# UNITED STATES PATENT AND TRADEMARK OFFICE

APPLICATION NO.	FILING DATE	FIRST NAMED INVENTOR	ATTORNEY DOCKET NO.	CONFIRMATION NO.
10/663,918	09/16/2003	Richard A. Wilsak	37,512	2288

<b>Office Action Summary</b>	<b>Application No.</b> 10/663,918	<b>Applicant(s)</b> WILSAK ET AL.	
	<b>Examiner</b> /Robert James Popovics/	<b>Art Unit</b> 1797

DETAILED ACTION

Figure 1 Annotated in View of The Example

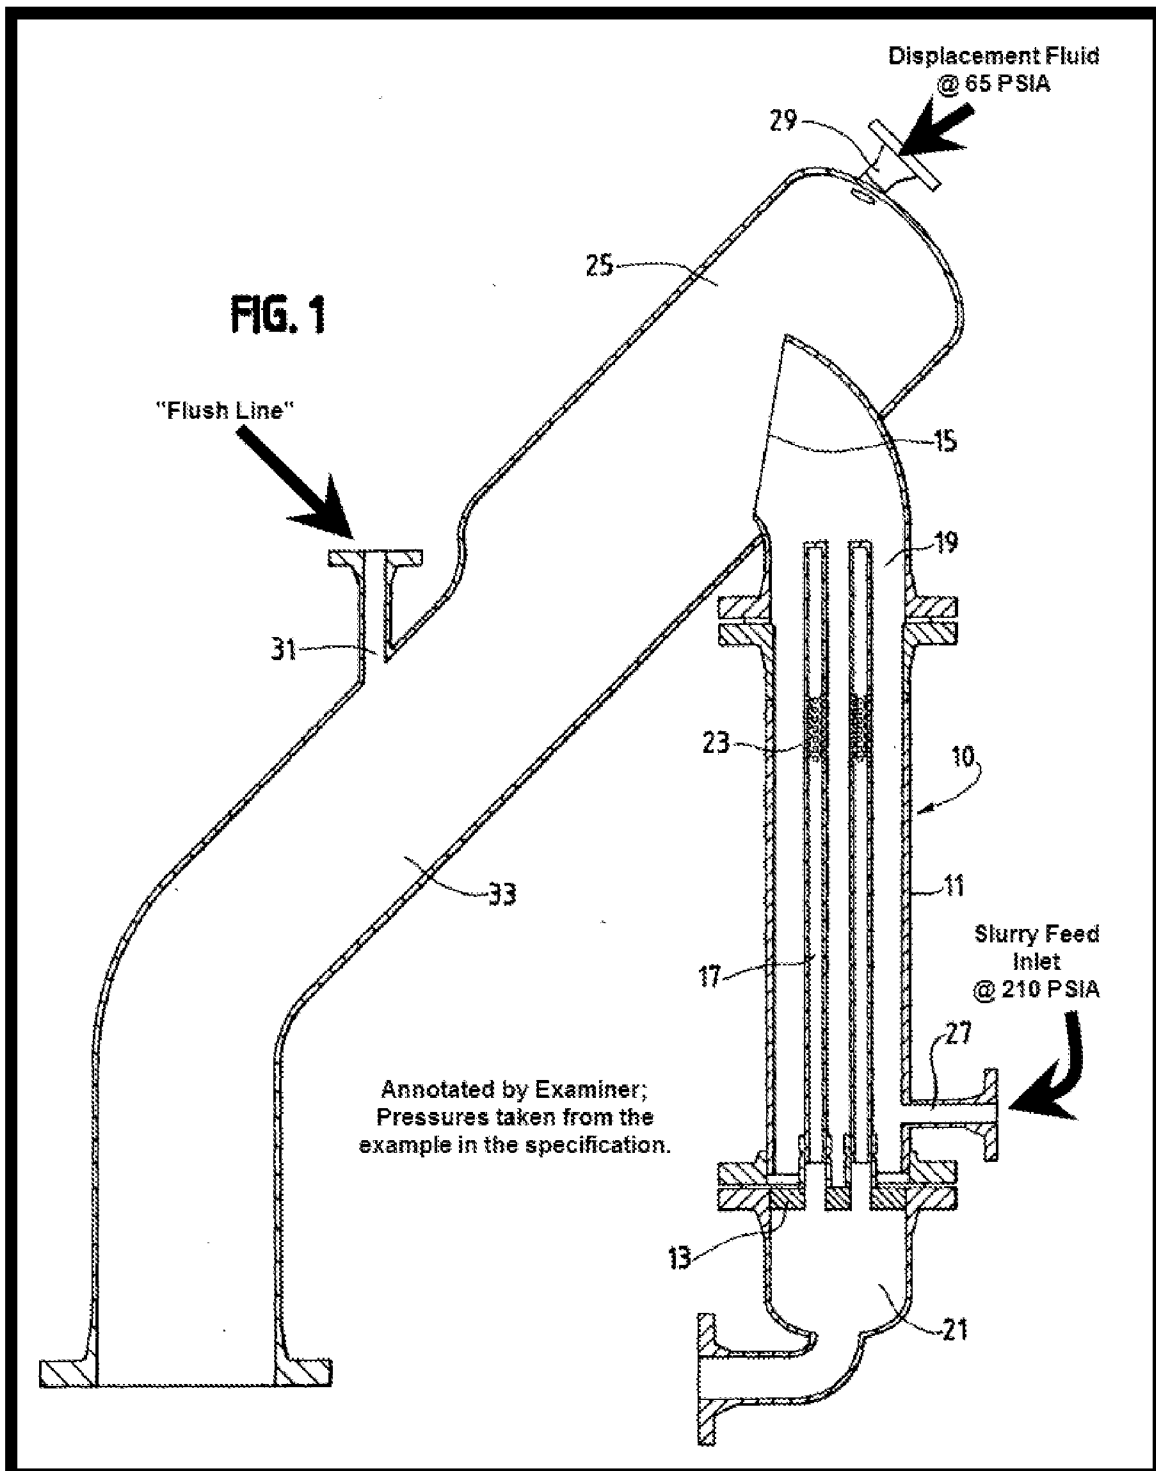
In this regard, it is noted that the only apparatus disclosed to accomplish this step is Fig. 1, which discloses an open chute 33. As such, it is unclear how the above stated step would be accomplished. It is axiomatic that a fluid under pressure will follow the path of least resistance. Referring to Fig. 1, that would be chute 33.

Unfortunately, this argument is not commensurate with the scope of the claims, which were previously amended to specify that all steps took place simultaneously. When the process steps all take place simultaneously, there are no "initial" steps. Applicants later refer to the sole example in the case, when challenging the rejections made. After considering the pressures set forth in the sole example, it is unclear how any displacement fluid at 65 PSIA will simultaneously flow down filter column 10, when slurry at 210 PSIA is being introduced thereto via slurry feed inlet 27. Applicants trivialize the controls/valves necessary to practice the invention, citing to Hybritech. Unfortunately, the undersigned disagrees, considering those controls essential to the practice of the invention. Applicants' arguments, citing to the sole example, only serve to bring more questions to the surface. What would permit flow in a direction from a lower pressure (e.g., 65 PSIA) to a region of higher pressure (e.g., 210 PSIA)?

Comparing Figure 3 of **US 2007/0225539 A1** with Fig. 1 of the instant disclosure

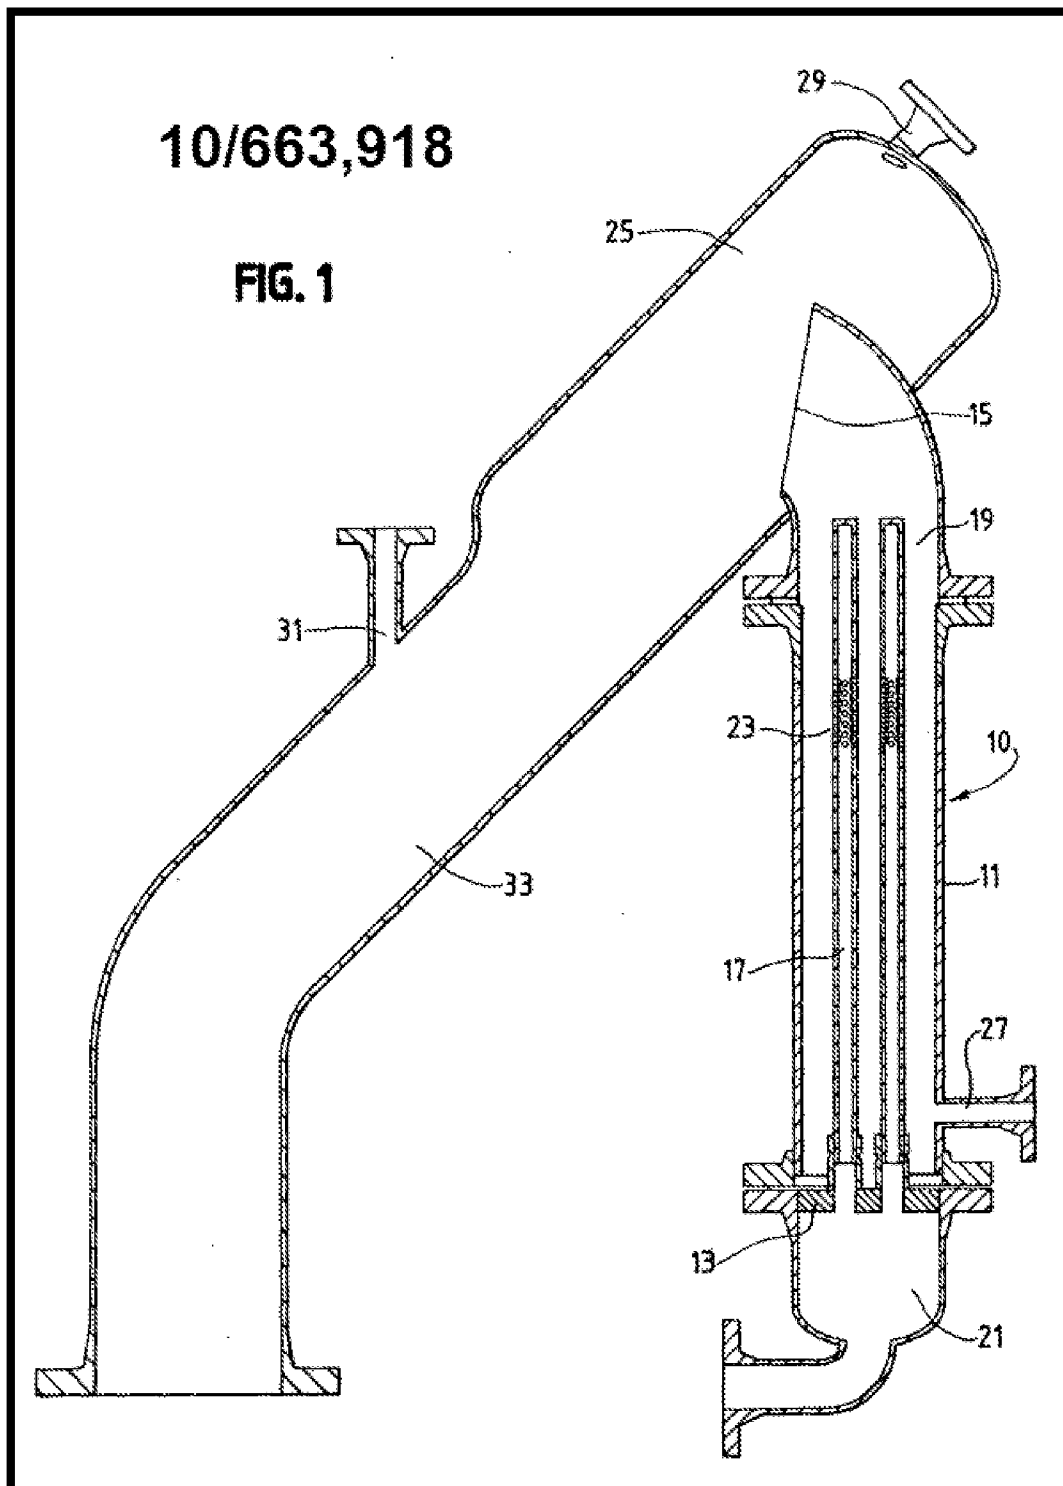
Claims **1,2,5-16,40,41,44,45,48 and 49** are rejected under 35 U.S.C. 112, first paragraph, because the **best mode** contemplated by the inventor has not been disclosed. Evidence of concealment of the best mode is based upon **Figure 3 of US 2007/0225539 A1**.

it would appear that something is missing. Specifically, there is no means disclosed for controlling the pressure at the open end of chute 33.

If, as Applicants have argued, "those skilled in the art, such as chemical engineers, would readily recognize both the need for and identity of appropriate pressure controls, such as valves and the like" and, that a "patent need not teach, and preferably omits, what is well known in the art," why then, have Applicants included a disclosure of such means in **11/277,073**? It is submitted that Applicants recognized the deficiency of this disclosure, and attempted to remedy it in **11/277,073**.
